**DOCUMENT 00 90 00**  
**ADDENDUM**

**ADDENDUM No.:** 1

**DATE:** March 3, 2023

**RE:** NORTHWOOD TECHNICAL COLLEGE  
RICE LAKE OFFICE RENOVATION  
1900 COLLEGE DERIVE  
RICE LAKE, WISCONSIN 54868  
PROJECT NO. 22039

**1 FIRST FLOOR REFLECTED CEILING PLAN**  
1/8" = 1'-0"

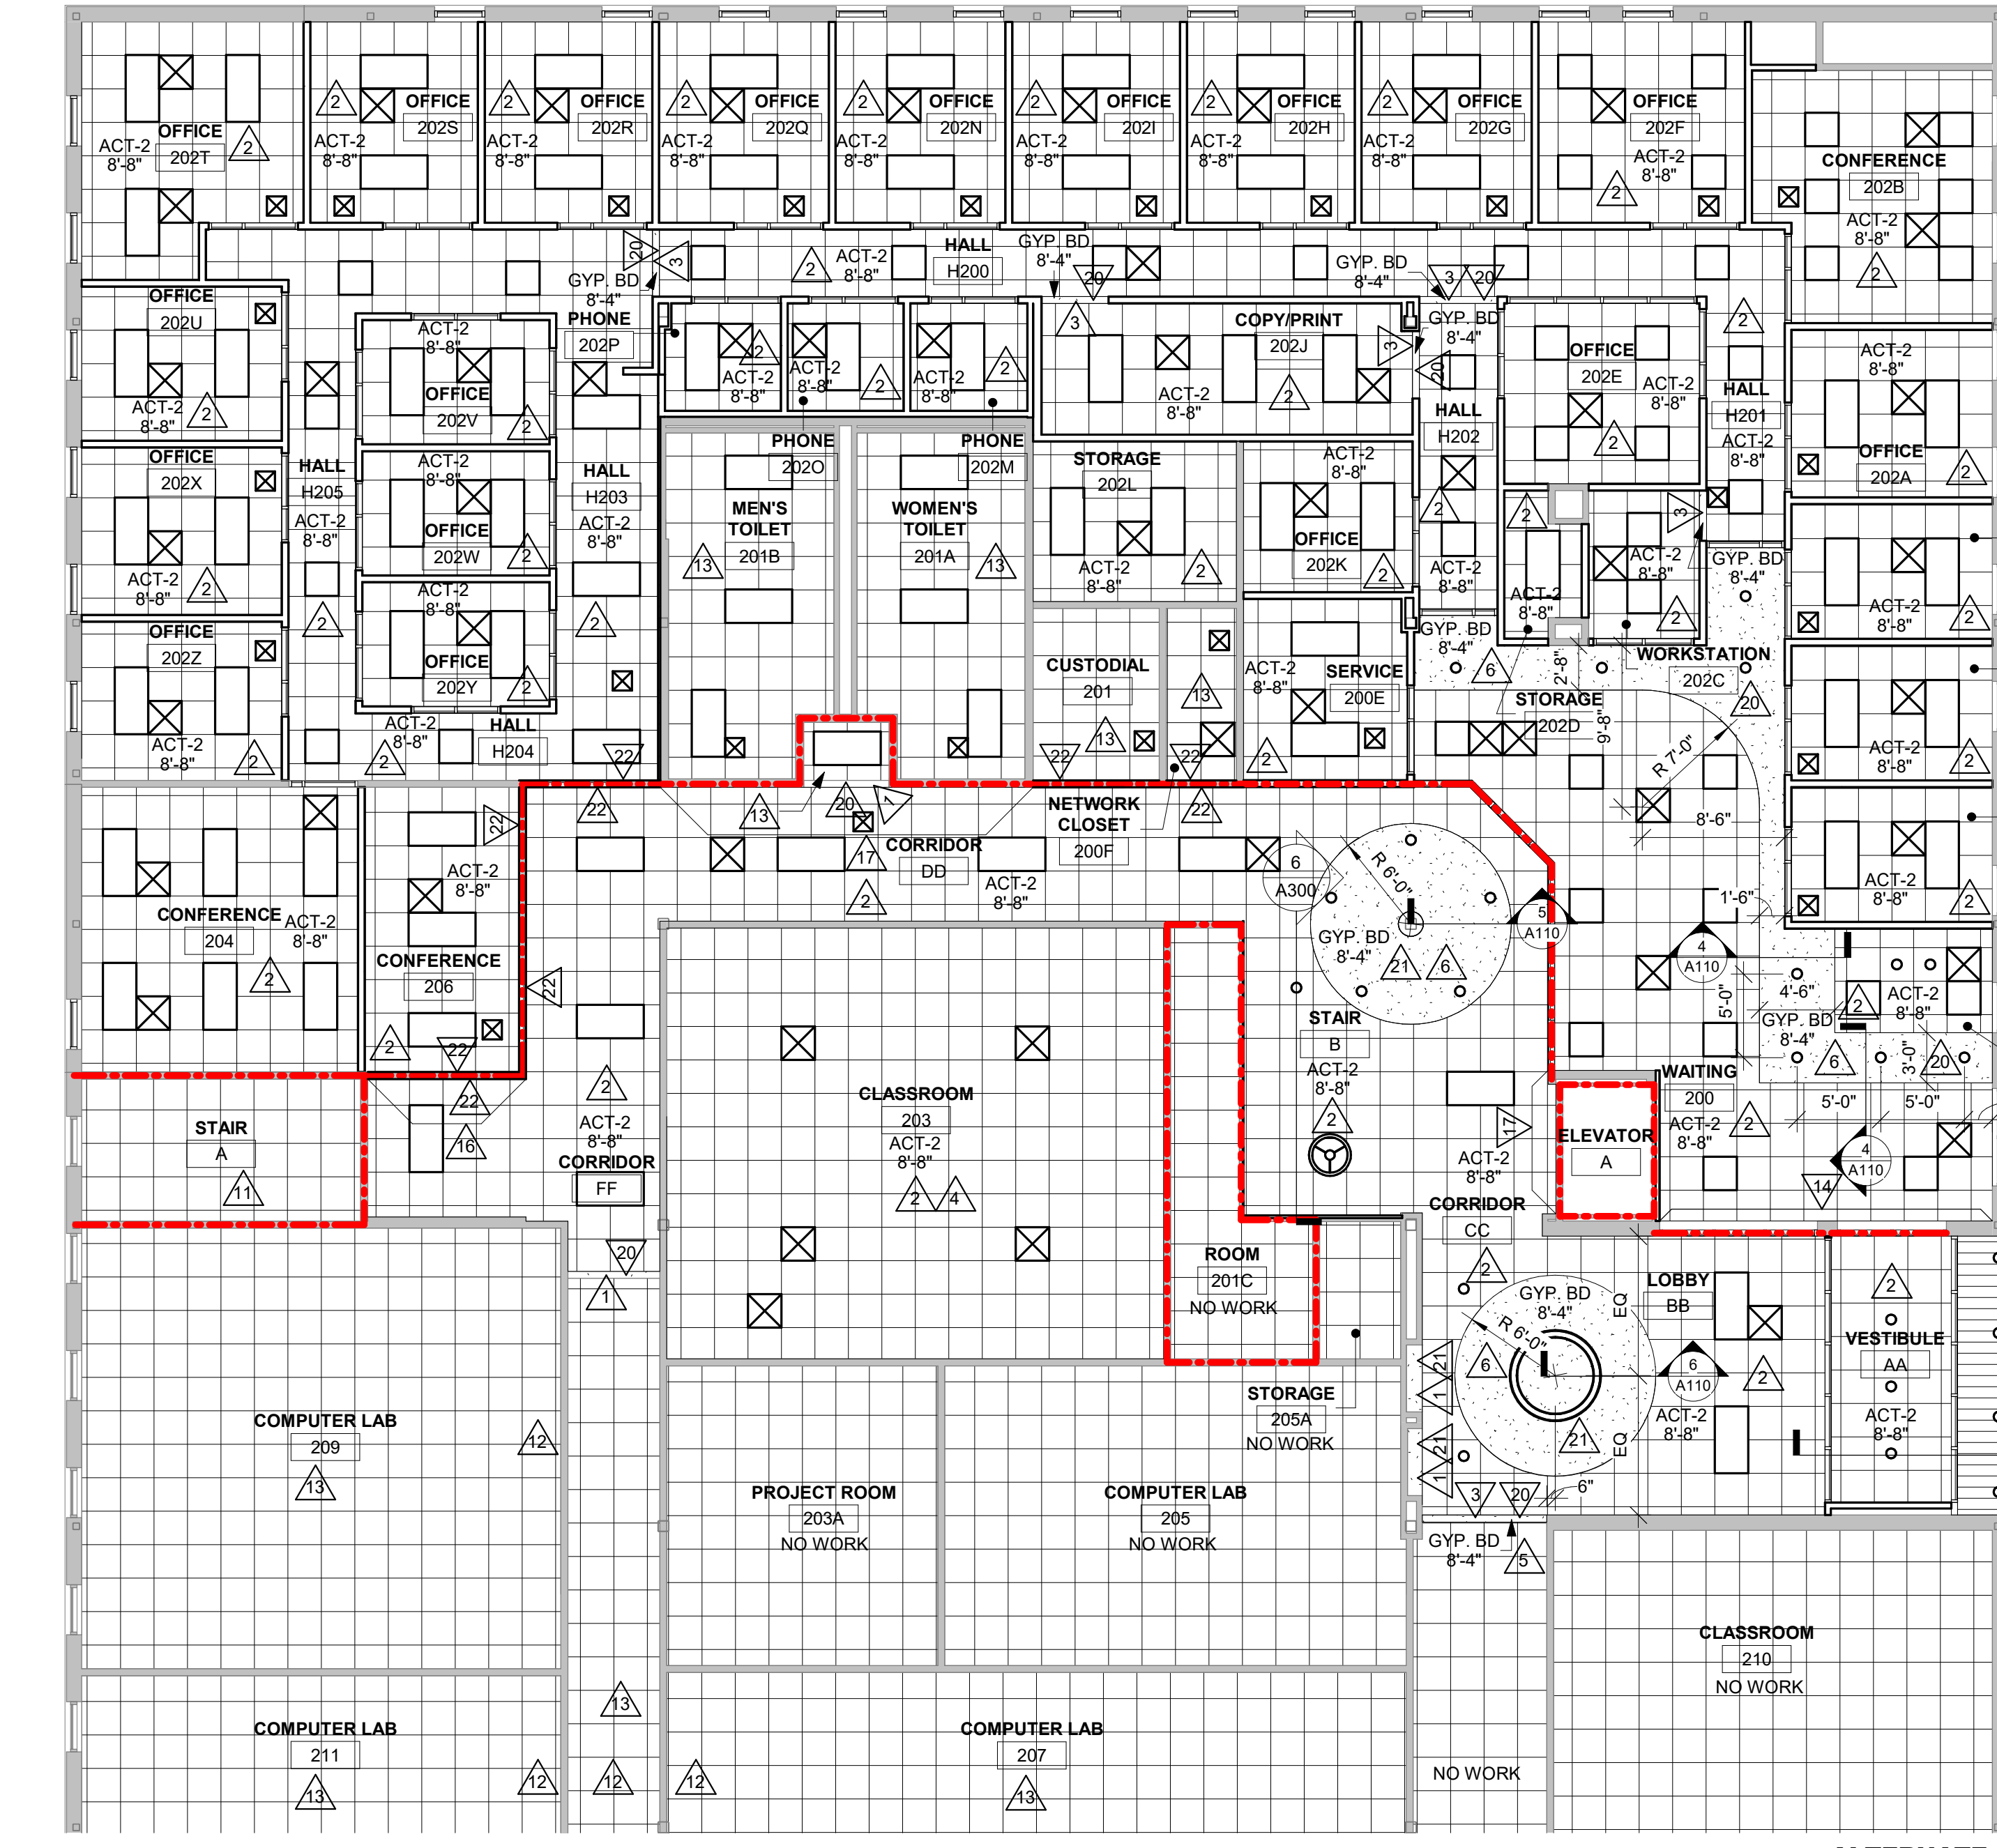
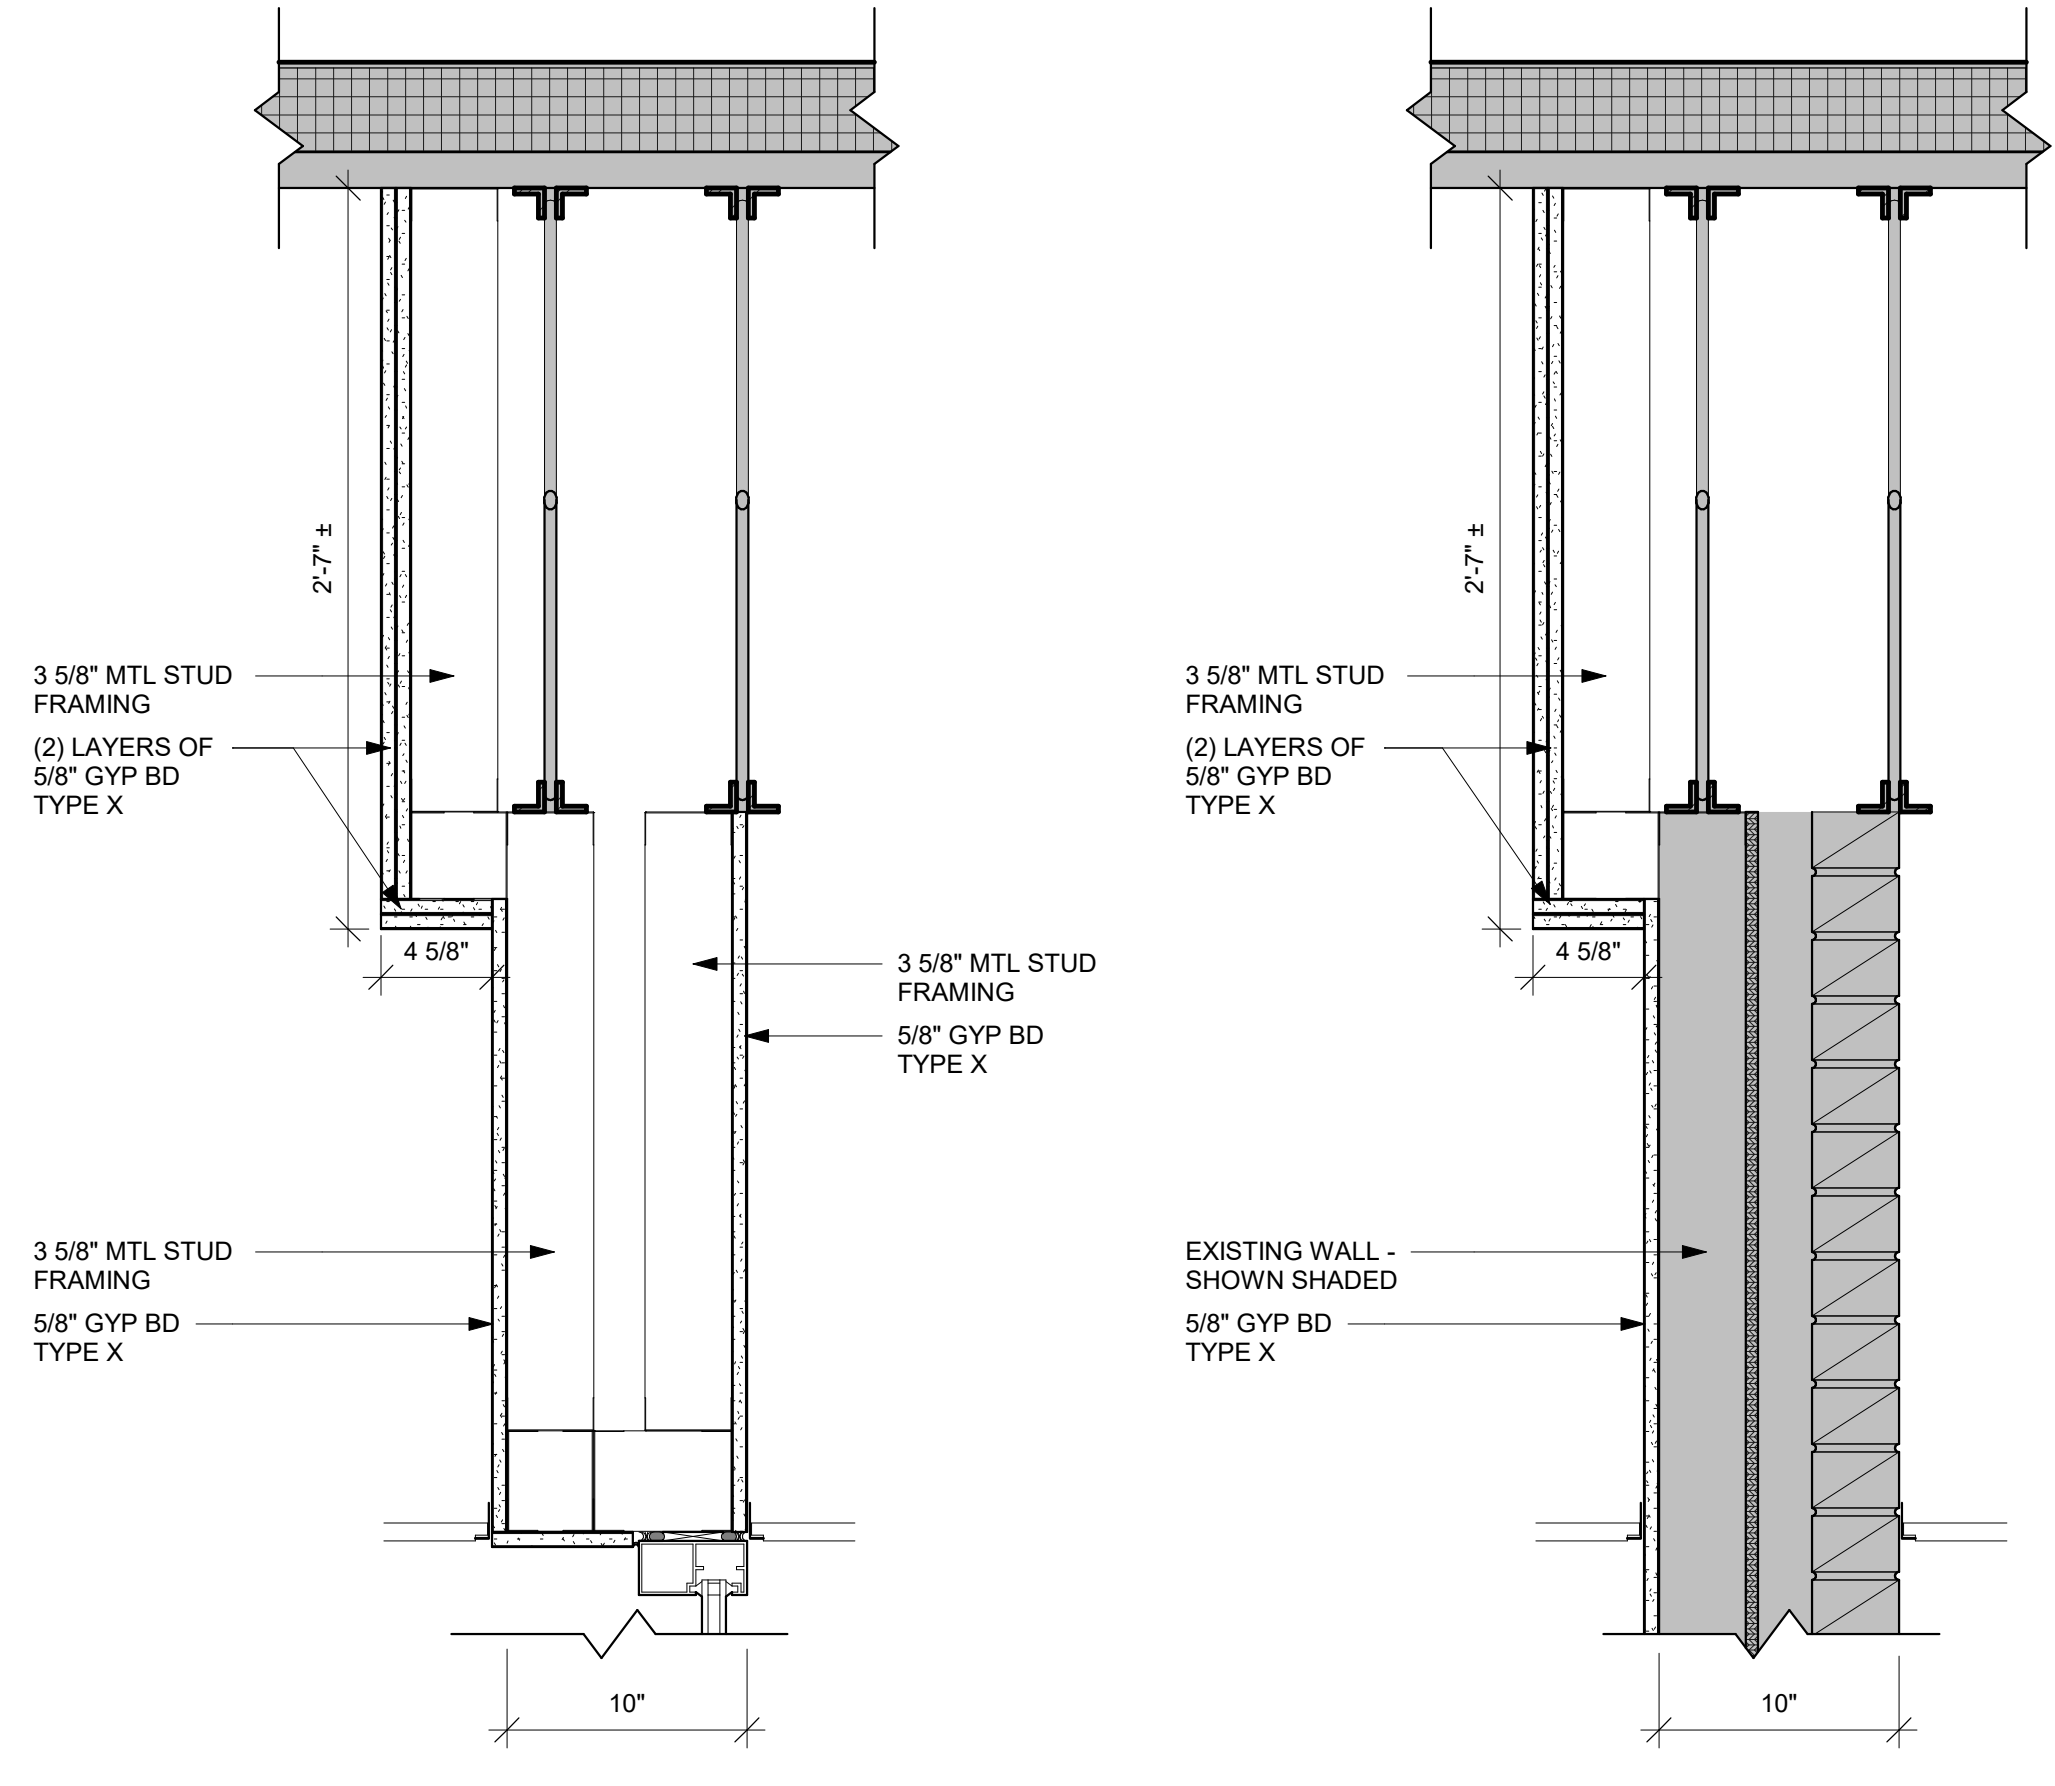
- b. Revised the description of Key Note 18 to indicate reinstallation of ceiling tile for access to mechanical work be done by the mechanical contractor.

- EXISTING TERRAZZO FLOOR TO REMAIN.
- EXISTING CARPET FLOORING TO REMAIN.
- REMOVE EXISTING CEILING TILE FOR MECHANICAL PIPING WORK - SEE MECHANICAL. SALVAGE TILE FOR REINSTALLATION. TILE REMOVAL AND INSTALLATION TO BE BY MECHANICAL.

**ID101**

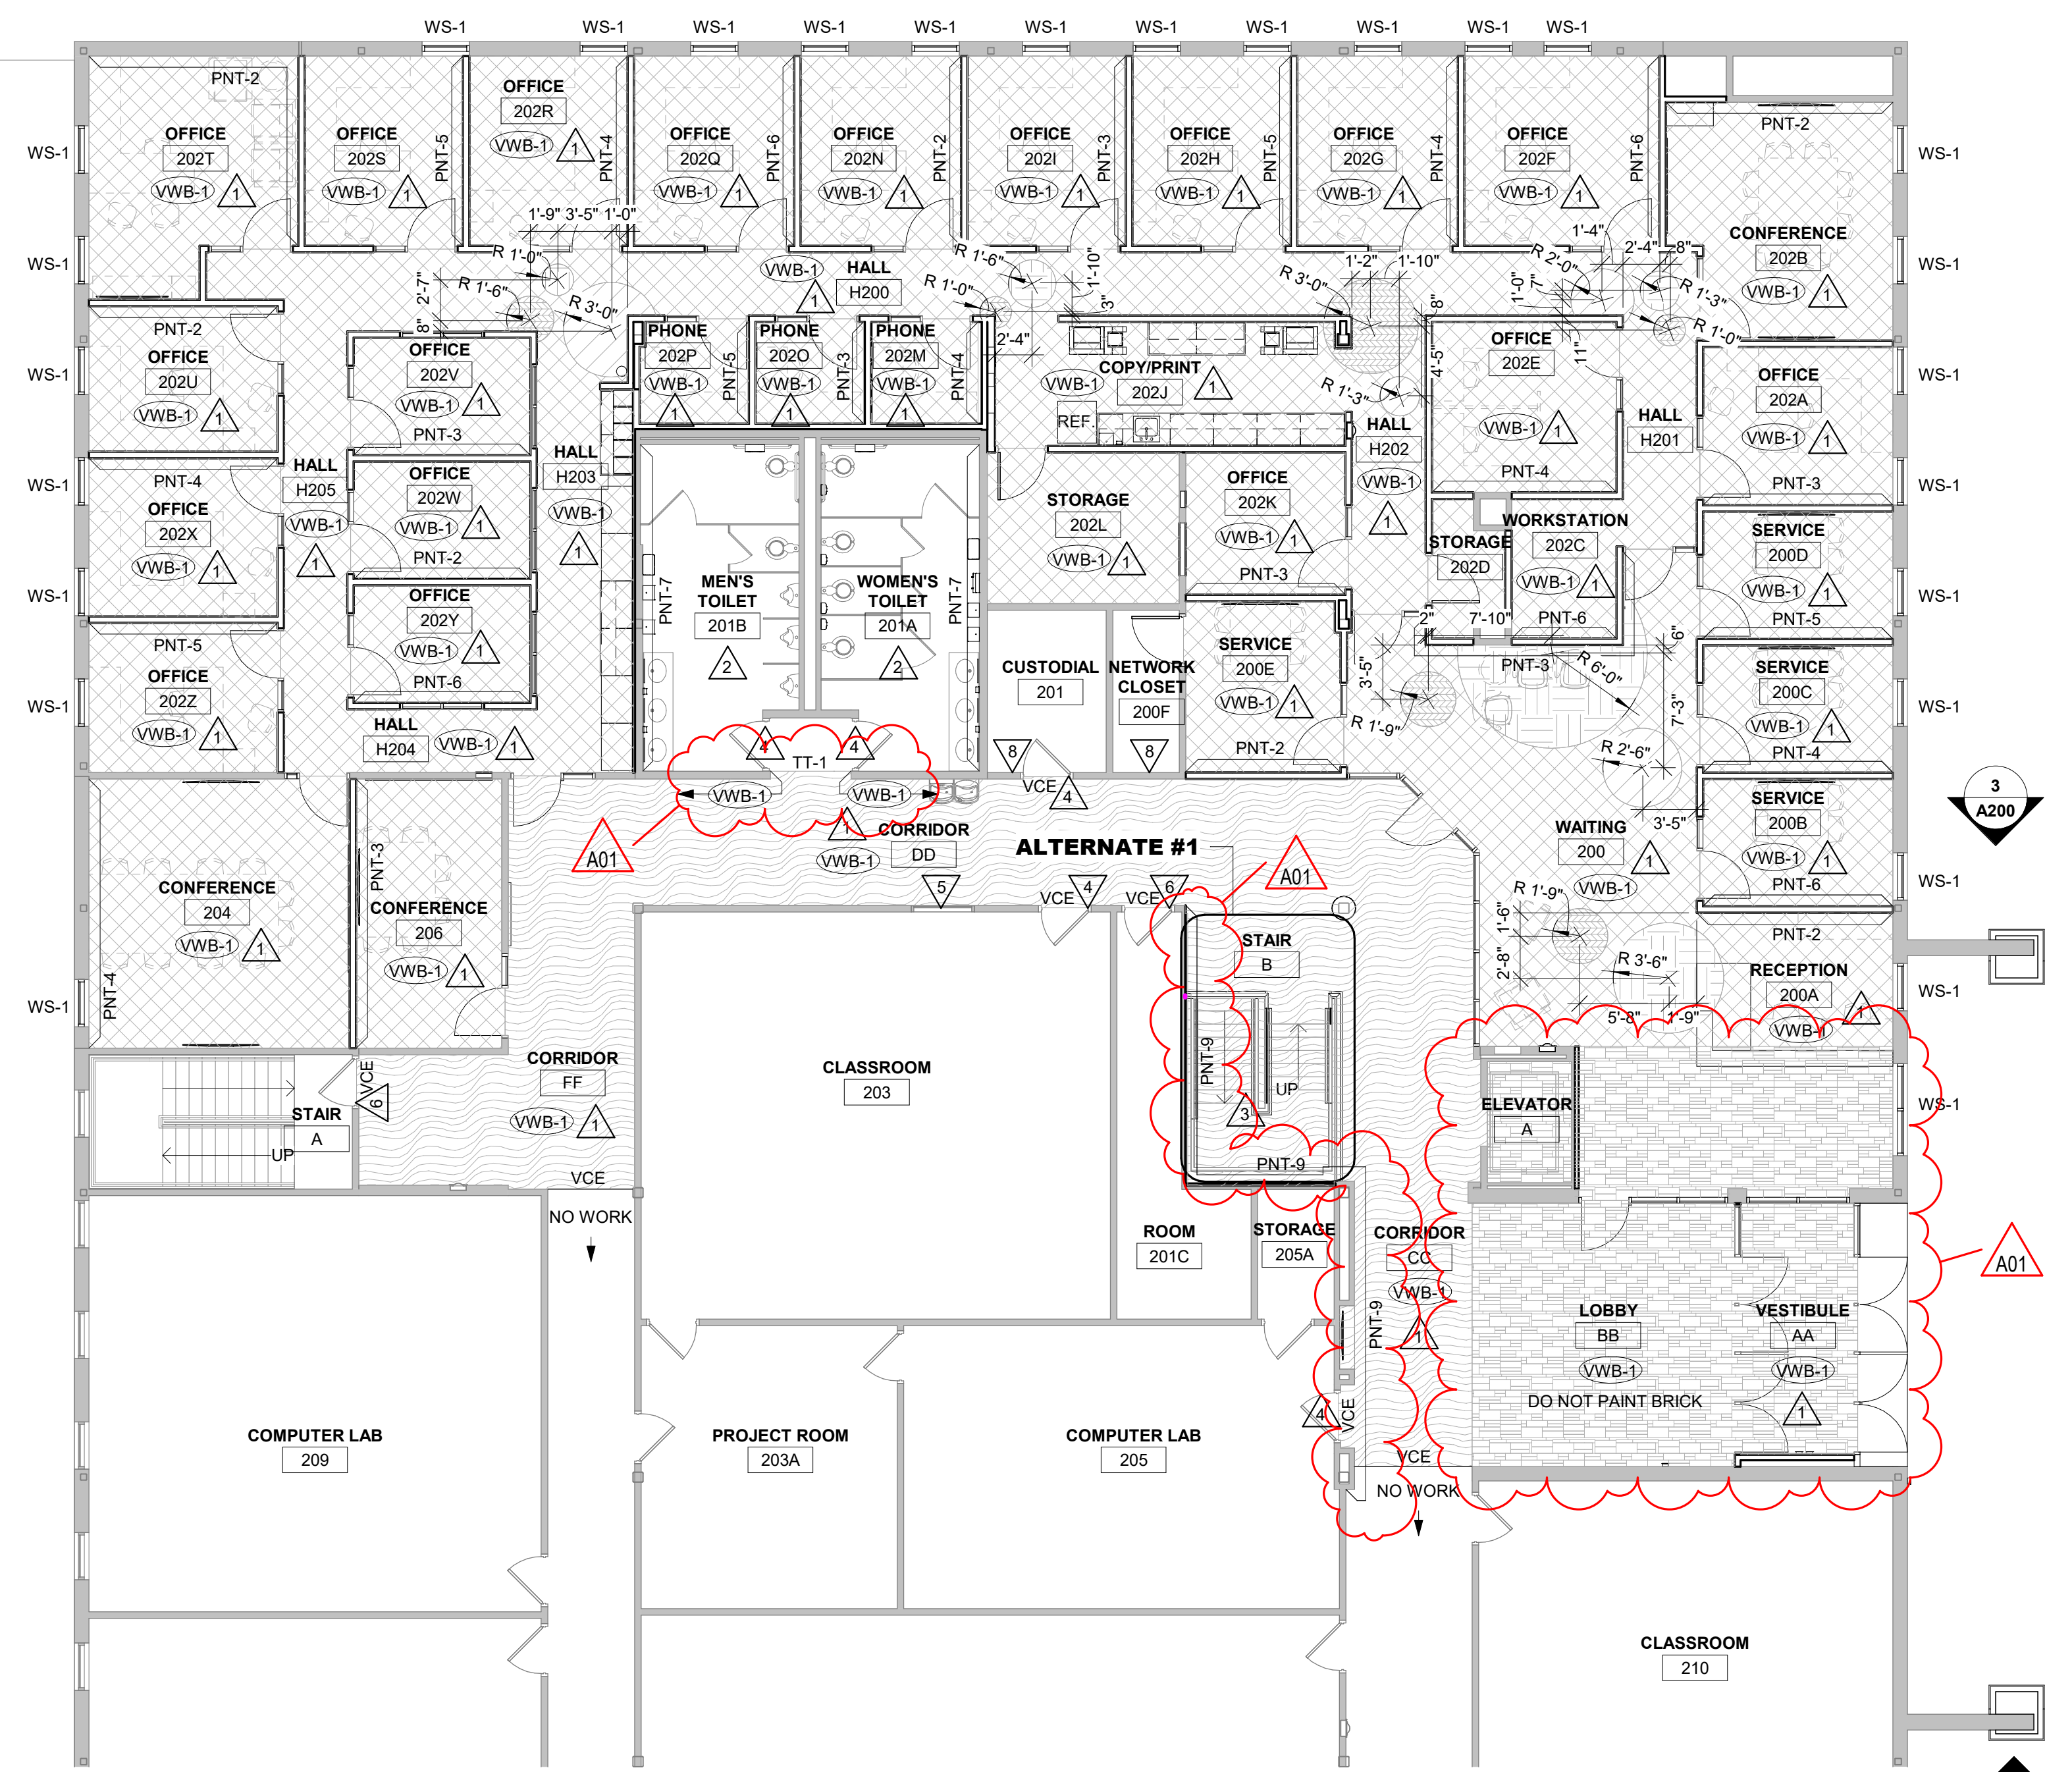
7. Sheet ID101 FINISH FLOOR PLAN 30"x42"
  - a. See the revised sheet included in this addendum. Disregard the previous version.
  - b. Changed paint color at Corridor CC and Stair B.

- c. Added vinyl wall base at a portion of Corridor DD and extended LVT-1 at the threshold of toilet rooms 201A and 201B.
  - d. Revised hatching for WCPT-1 for improved clarity.
